## PRODUCT SAFETY RECALL

### Woodman DP-CH-18/1 Floor and Bench Drill Press Models

**Product SKU:** T-P\*DPCH-18F/1 and T-P\*DPCH-18/1

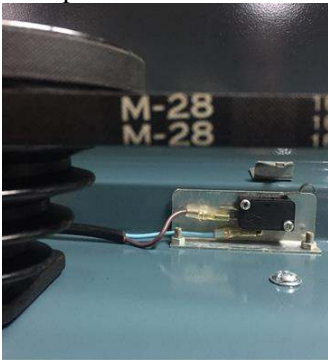
**Defect:** The Drill Press has exposed wires and terminals on the limit switch inside the pulley cover. See example below:

**Hazard:** Possible electric shock, serious injury or death.

**Rectification:** Heat shrink must be applied over exposed wires and terminals on the limit switch inside the pulley cover. See example below:
